Assessment Officer Report

6 Falls Creek Road and unleased Crown
land abutting Falls Creek Road, Falls Creek
PA2403179

Officer Assessment Report Development Assessment

Figure 8 – Existing building roof plan showing vegetation to be removed – (Source: Application)

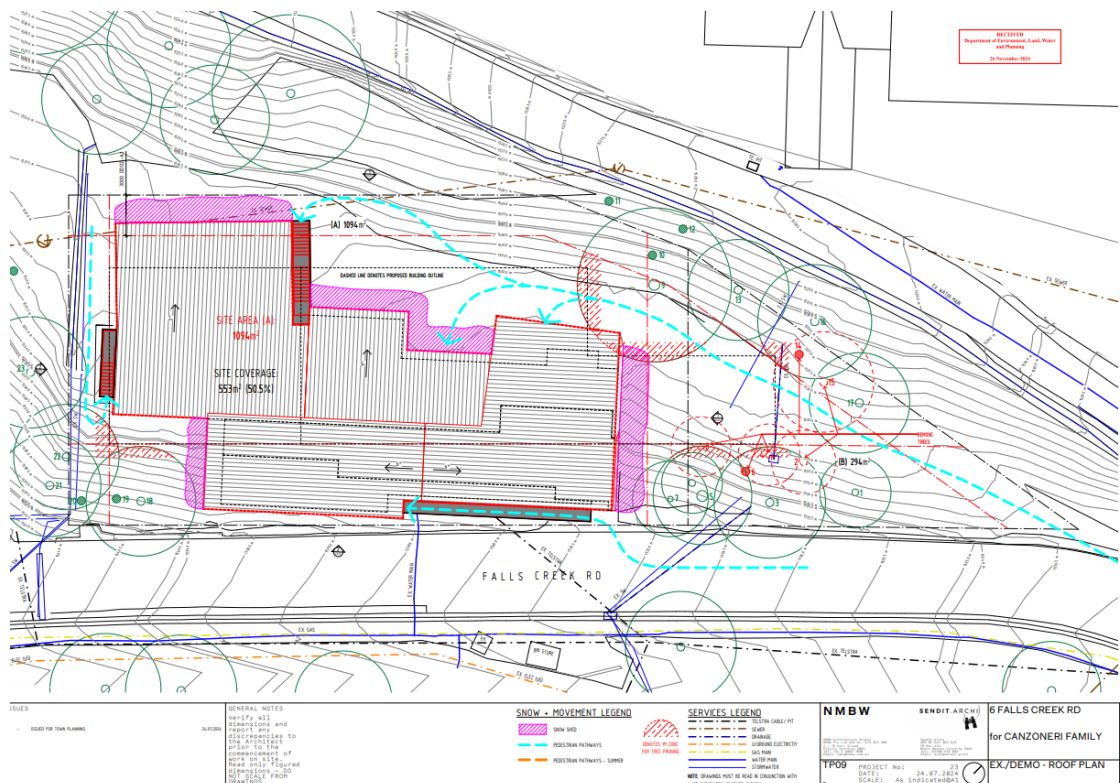
75. The proposed development will result in the removal of native vegetation which requires planning approval in accordance with Clause 52.17-1 of the scheme. The removal of native vegetation will not result in the net loss to biodiversity. This has been achieved by applying the three-step approach in accordance with the *Guidelines for the removal, destruction or lopping of native vegetation* (Department of Environment, Land, Water and Planning 2017) (the Guidelines). The assessment concludes that the proposed development will require the removal of 0.015 hectares of native vegetation, including two large trees, within a patch. This includes a total of 6 trees to be removed, specifically nominated as Tree No's 2, 4, 6, 8, 14 and 15, all of which are located to the eastern section of the site.

77. The application was referred to DEECA informally to provide comments in relation to the native vegetation removal, noting that the native vegetation removal follows the 'intermediate assessment pathway' and as such is not a formal referral to DEECA. The comments include standard conditions relating to the provision of offsets to be secured for the removal of 0.015 hectares including 2 large trees. The offset requirements will be 0.007 general habitat units with a minimum strategic biodiversity score of 0.216.

78. Standard conditions around the protection of any vegetation to be retained will be included on any permit issued as well as ensuring offsets are secured and include the protection of at least two large trees,

Figure 12 – Overshadowing impact to The Hub at 9am (winter solstice) – (Source: Application)

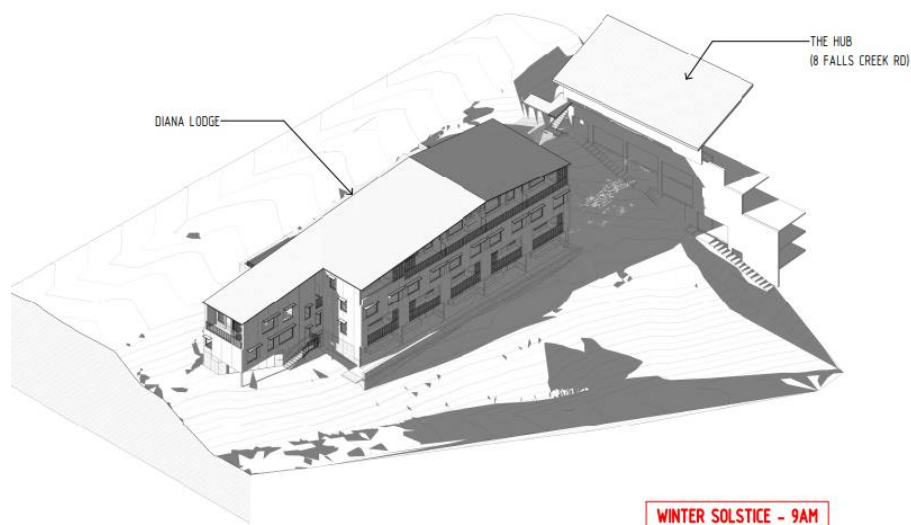
62. One objection was received from the adjoining property to the west (The Hub located at 8 Falls Creek Road) raising concerns that the proposed development will cause unreasonable overshadowing to the lower level apartments and to the staircases of The Hub building. The objection describes the perceived effects of overshadowing including ice hazards forming on the east side stair case as a result of reduced sunlight, increased energy costs and reduced solar access to the land on the east side of the building that is often used by children for sledding.

65. Notwithstanding the above, in response to the concerns raised, the applicant prepared shadow diagrams (autumn/spring equinox and the winter solstice) to demonstrate the extent of overshadowing expected from the proposed development. The shadows indicate that The Hub will be mostly affected at 9am on the winter solstice. (Refer to Figure 12). At 12 noon, there will only be a small amount of overshadowing predominantly at the external stairs.

66. While overshadowing is not required to be taken into consideration under the objectives and standards to Clause 58, and again in a limited capacity within DDO2, it is considered that the shadow diagrams demonstrate apartments on the east side of The Hub and the land between the two sites will continue to receive adequate sunlight for most of the day and the extent of overshadowing expected to occur cannot be considered as having an unreasonable impact to the adjoining apartments.
